SUBJECT: APPLICANT'S RESPONSES TO CEC STAFF DATA REQUESTS 1-71
ROSEVILLE ENERGY PARK (03-AFC-01)

Roseville
ENERGY
Park

03-AFC-01

California Energy Commission Staff
Data Requests 1-71

Manufacturer's Part-Load Emissions Data For NO_x, CO, and VOC

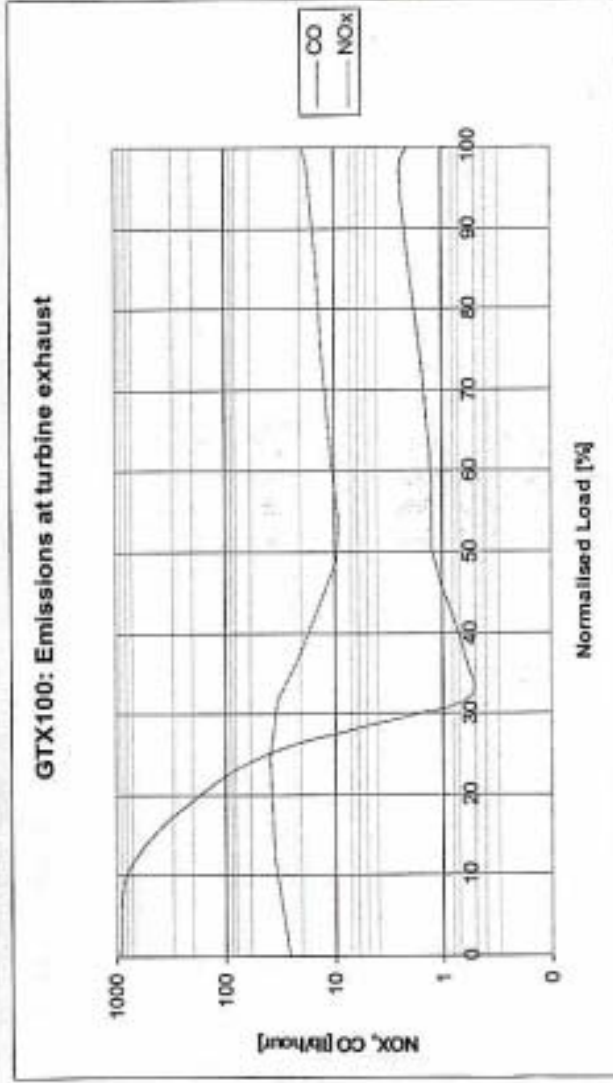
3 The startup emission estimates for the GTX 100 are significantly different from previous filings (e.g., Malburg Generation Station). Please provide the source or basis for the startup emission estimates for the GTX 100 turbines.

Response: Startup emissions estimates for the Roseville Energy Park GTX100 alternative were based on manufacturer's data provided by Alstom (now Siemens) coupled with the combined-cycle startup operating assumptions. Attachment AIR-1 includes the manufacturer's part-load emissions data (lb/hr versus percent load) for NO_x, CO, and VOC.¹ Attachment AIR-2 includes the Applicant's detailed calculations for the maximum hourly and total emissions per start for hot, warm, and cold starts. These calculations are somewhat conservative in that they assume no reductions by the SCR and oxidation catalyst until the gas turbine load is greater than 50 percent.

Figure DR45-1
Revised Figure 2.2-2

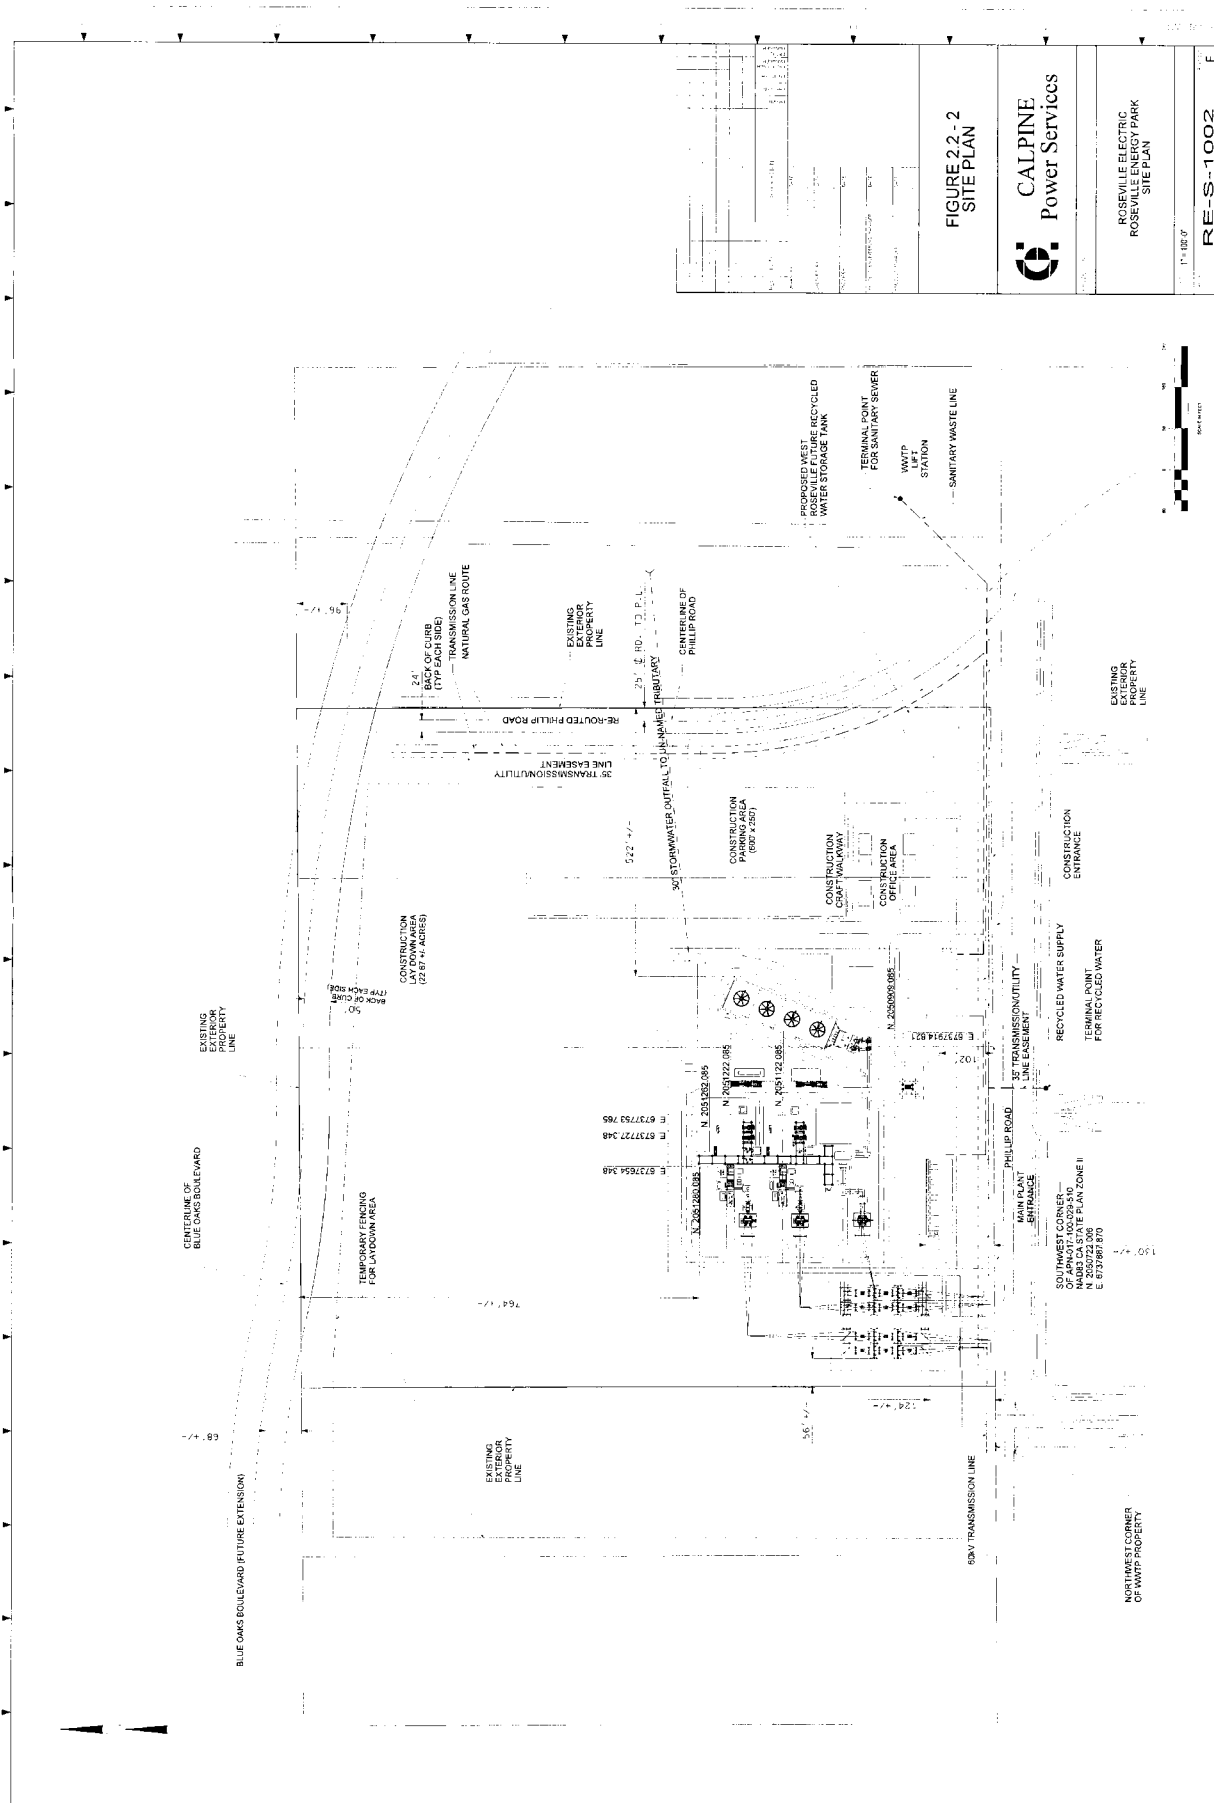
45 Revise Figure 2.2-1 Site Layout Map in the application to provide the:

Response: Because of its scale, AFC Figure 2.2-1 is not the appropriate figure upon which to show information such as the north property line, the future extension of Blue Oaks Boulevard, and the future re-routed Phillip Road. These features would all fall outside the figure boundary. In response to this request, the Applicant has provided a revised version of AFC Figure 2.2-2 as Attachment LU-1 (Figure DR45-1).

Response: Figure DR45-1 shows seven parcels, all of which are presently owned by the City of Roseville. The REP will be constructed on three of these parcels. The outer limits of these three parcels are identified as "EXISTING EXTERIOR PROPERTY LINE" and distances from each property line to the closest project structures are shown. Any existing structures on the project property are temporary structures associated with the construction of the Pleasant Grove Waste Water Treatment Plant. These structures will have been removed prior to construction of the REP

Response: The centerlines of the future re-rerouted Philip Road and the future extension of Blue Oaks Boulevard are now both shown on Figure DR45-1, along with the distances from the project property lines. In both cases, portions of the roads will be located on the project property, but well away from the project structures.

Response: Figure DR45-1 shows the dimensions from the centerline of road to the back-of-curb for both the future re-rerouted Philip Road as well as the future extension of Blue Oaks Boulevard. The distances from the back-of-curb to the project property lines can be calculated from this information along with that contained in response to item (b).
